**Historical Architectural Review Board  
COA Preliminary Review Sheet**

**HDC-2024-00028**

**Address: 825 W Gordon Street**

**Proposal: Replace front door**

**Existing Door (Applicant)**

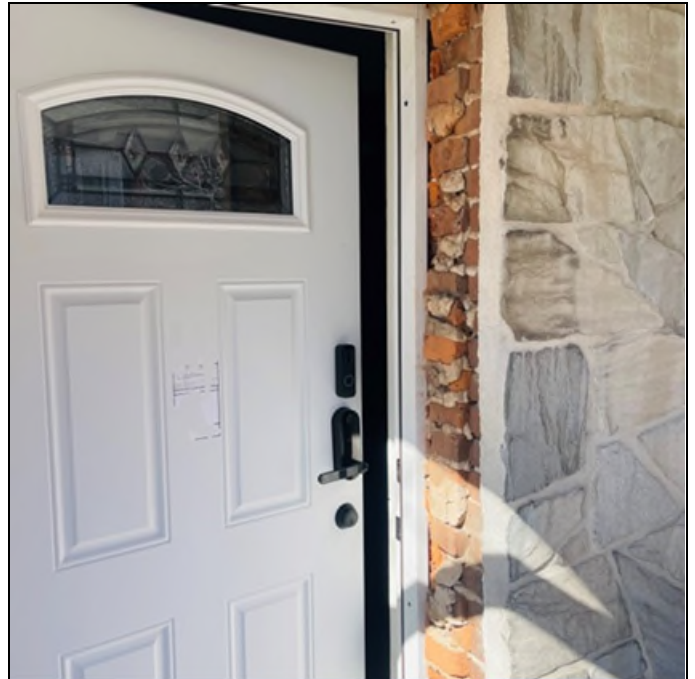
**Observations & Comments:** If the door is beyond feasible repair, replacement with the proposed metal door is not historically appropriate. Ideally, the wood door with original, character defining detailing would be retained and repaired. This door contains an immense amount of character defining features, including the bottom panel detailing. From the photographs, it does not appear that the door material is in poor condition, so perhaps upgrades to the hardware and/or weatherization is more appropriate, instead of replacement.

**Discussion:** It was noted that this application is related to a violation correction. The applicant noted he was new to Allentown and was not aware of the rules and regulations. He noted the door was in bad condition and when he tried to change the lock, the wood was bad, and he was not able to change the lock. The applicant clarified that the masonry opening was not altered, the wood trim was just removed around the opening. Generally, it was noted that the door appears to be in repairable condition and the applicant agreed to rebuild the jamb and repair the existing door, which he still has in his possession. Dave noted the existing wood could be reused and replaced as necessary and a storm door could

**Staff Recommendation:** It is recommended to deny the application. The original door should be retained if at all possible.

**Action:** Mr. Huber made a motion to deny the application presented on May 6, 2024, for the door replacement at 825 W Gordon Street because it did not comply with the Guidelines for Historic Districts: Chapter 3, Section 3.6 – Doors and there were no known unique circumstances that would apply. It was recommended that the original door and jamb be replaced to their original condition and that a full view storm door would be acceptable if the applicant chooses.
